# HISTORIC AND DESIGN REVIEW COMMISSION

**HDRC CASE NO:** 2020-416  
**ADDRESS:** 514 W QUINCY  
**LEGAL DESCRIPTION:** NCB 16821 BLK 1 LOT 3 (SAISD CENTRAL OFFICE)  
**ZONING:** D,RIO-7A  
**CITY COUNCIL DIST.:** 1  
**APPLICANT:** Liz Hurd/RVK Architects  
**OWNER:** Kamal ElHabr/SAN ANTONIO ISD  
**TYPE OF WORK:** Construction of a multi-story parking garage, signage  
**APPLICATION RECEIVED:** September 18, 2020  
**60-DAY REVIEW:** Not applicable due to City Council Emergency Orders  
**CASE MANAGER:** Stephanie Phillips

# Bexar County - Quincy Street Parking Garage

VIEW FROM N. FLORES

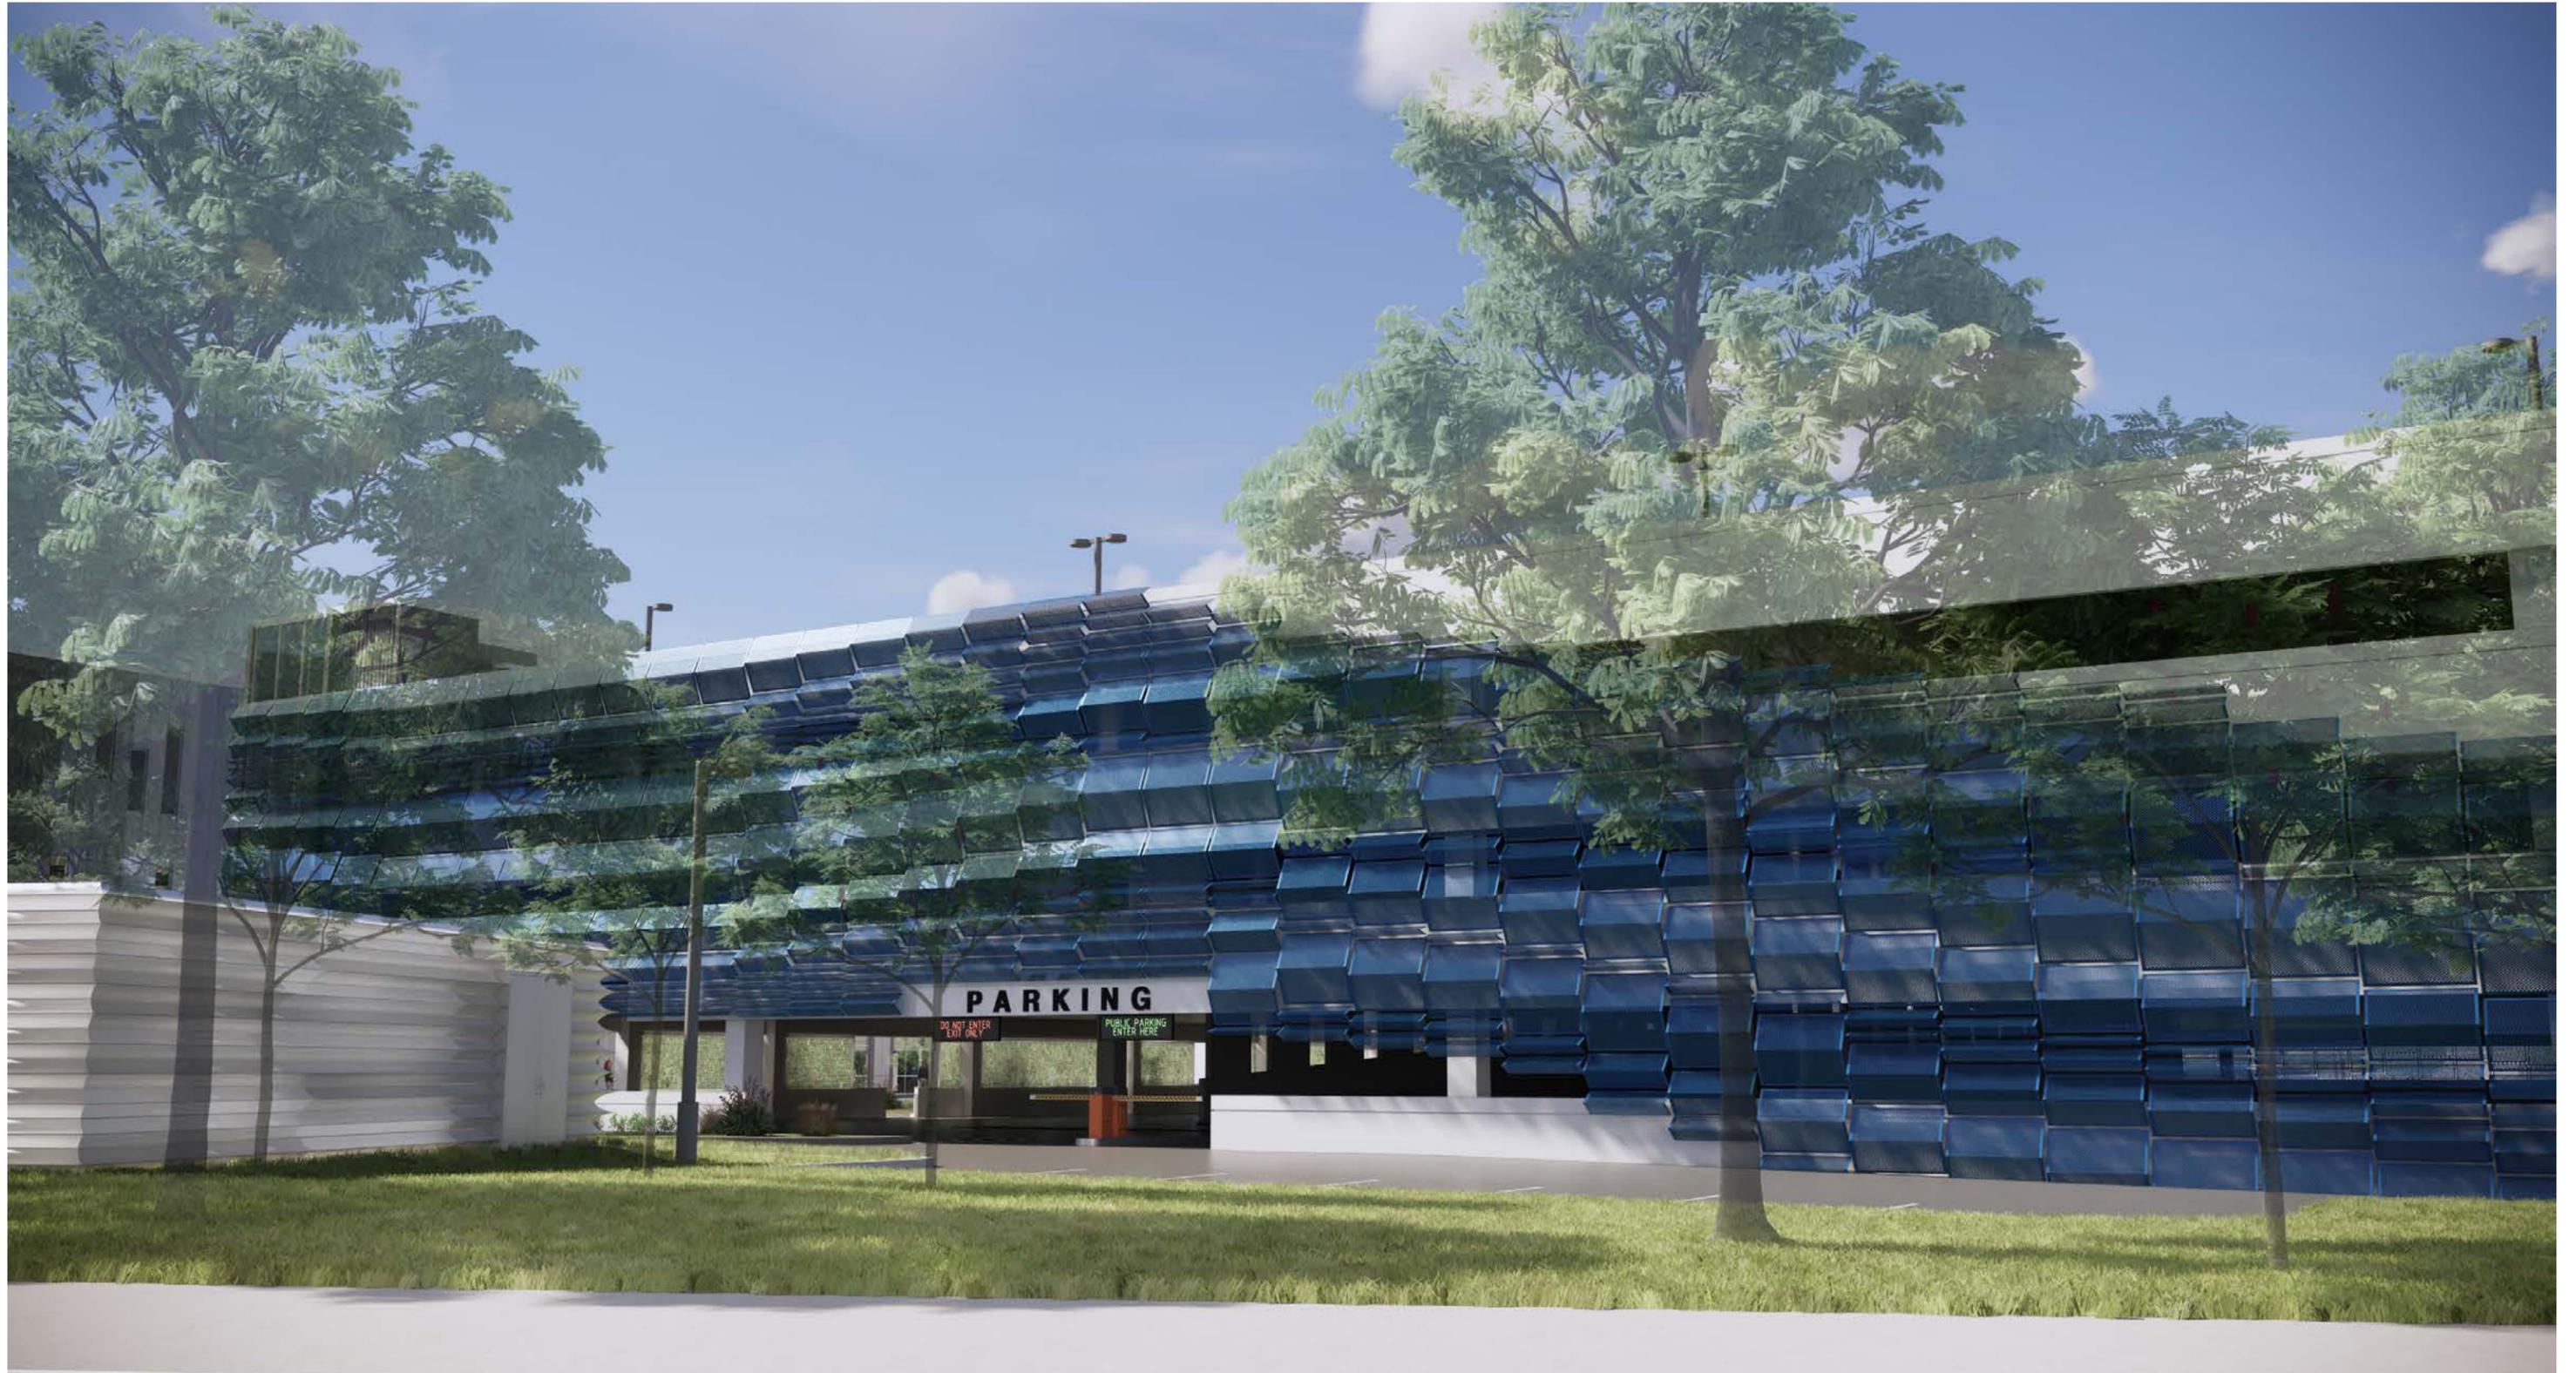
2. Also, the orientation/height of the stair tower - rotating it to relate it more to the admin bldg. rather than just a square corner of the garage

The design team did study this request and any rotation of the stair reduces the pedestrian landing area outside of the stair, as well as sight lines, in relation to the internal drive and creates a potential unsafe condition between pedestrians and vehicles. In addition, the angle and / or rotation does not work within the rhythm and boundaries of the structural systems creating an inefficiency that is outside of the current GMP.
